PL3	1/14/2022	ED	-	-	ISSUED FOR PLANNING ALTERATIONS ADDITIONAL INFORMATION
Mark	Date	By	CHK	App.	Reason
Drawing Status					
PLANNING ALTERATIONS (A.1.)					
Job Title					
INDUSTRIAL DEVELOPMENT AT TAY LANE, GREENOGUE RATHCOOLE, Co. DUBLIN					
Drawing Title					
SITE PLAN WITH PROPOSED FENCE					
Architect/Draw					
ELECTRICAL WASTE MANAGEMENT LTD					
<p>KAVANAGH BURKE CONSULTING ENGINEERS</p> <p>Tel. 01 - 450 0654 Unit F3, Calmount Pk. Fax. 01 - 426 4340 Ballymount, Email: pkavenagh@kavanaghuburke.ie Dublin 12.</p>					
Drn	GS	Checked	FL	Approved	PK
Scales	1:500	Date	April 2022		
Job No.	D1541	Drawing No.	D2A	Rev.	PL3

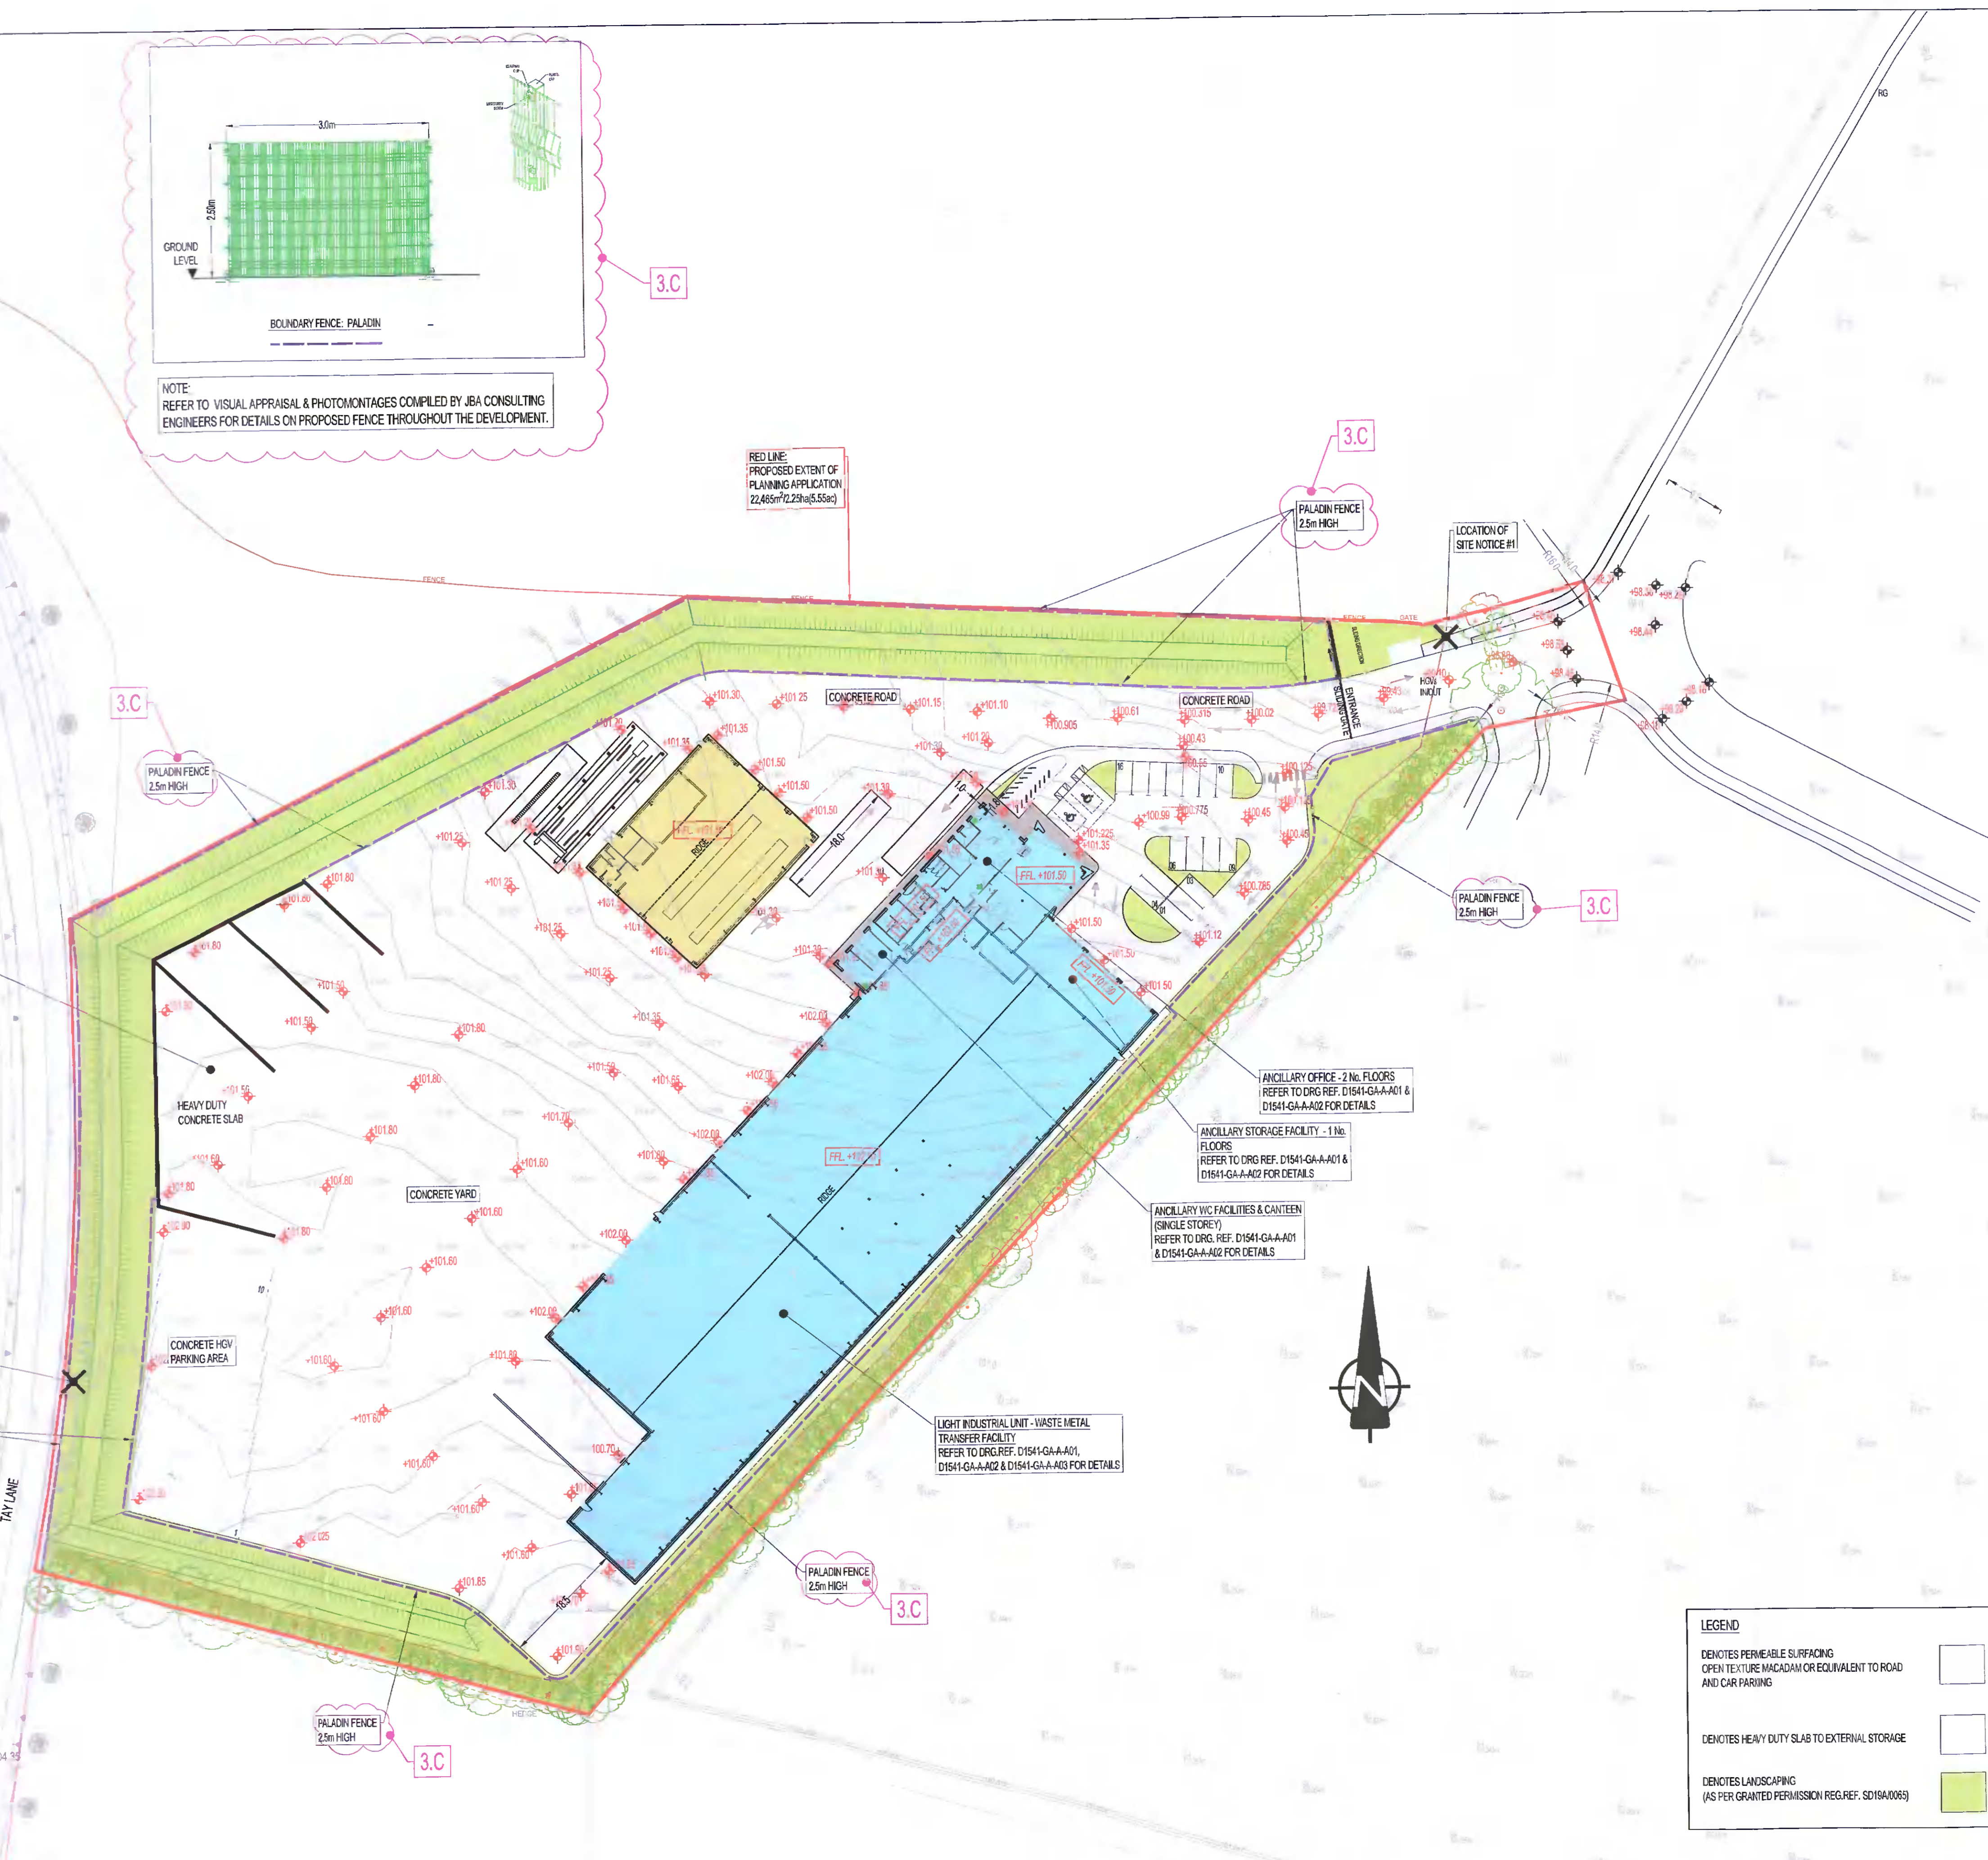
The subject alterations for which planning permission is sought for are as follows:

1. RECONFIGURATION OF THE FLOOR PLAN AREAS AS FOLLOWS:

A. Provision of 535m² additional floor area due to introduction of areas as follows:

- A.1. Extended display area at ground floor of ancillary Office, addition of 46m² floor area;
- A.2. Extended open plan office at first floor of ancillary office, addition of 20m² floor area;
- A.3. Single storey ancillary storage facility to the front north-east elevation, totalling 166m², overall height 7m;
- A.4. Mezzanine area to the south eastern side of Light Industrial Unit, totalling 303m²;

Alterations listed above result in total building area increase from 4391m² to 4926m², as shown at the revised table of gross internal floor areas & uses.

B. Change of use of 64m² of Light Ind. Unit floor area to staff facilities due to the introduction of:

- B.1. Enclosed stairs from Light Industrial Unit to ancillary Office/Staff facilities (overall 31m²);
- B.2. Single storey cleaners store and storage at ground floor to the north-eastern corner of Light Industrial Unit (overall 33m²).

C. Change of use of 100m² of workshop charging area & staff facilities to workshop area & single storey office/staff facilities.

D. Introduction of full height dividing wall of Light Industrial Unit.

2. ELEVATIONS ALTERATIONS AS PER LIST ABOVE PLUS ADDITIONAL ALTERATIONS AS FOLLOWS:

- A. Provision of full height cladding (ground floor to roof) to Light Industrial Unit and ancillary Workshop;
- B. Introduction of 11m wide x 6m high cpe to Light Industrial Unit side (north-western) elevation;
- C. Rearrangement of all fire exit & level access doors to Light Industrial Unit & ancillary Workshop, including omission and addition of the same;
- D. Introduction of integrated modular louvre system to Light Industrial Unit rear (south-western) & side (north-western) elevation;
- E. Introduction of canopies to the ancillary Office main entrance and above 11m wide cpe & dock levelers to Light Industrial Unit side (north-western) elevation.

3. SITE PLAN ALTERATIONS AS FOLLOWS:

- A. Rearrangement of car parking spaces due to provision of Office extended display area to the front (north-eastern) elevation;
- B. Provision of new finish floor level to Office/Staff facilities and Workshop and associated site levels adjustments;
- C. Provision of a new boundary fence type (paladin fence) throughout the development;
- D. Provision of additional weightbridge, overall 2 no proposed and rearrangement of brush wash and steam wash between Workshop and site's north-western boundary;
- E. Provision of building protection bollards to Workshop side elevations (south-east and north-west);
- F. Associated drainage adjustments due to the inclusion of the alterations above plus reduction of surface water and foul sewer outfall route as per as built access road and services which serve built developments to the east of the site.
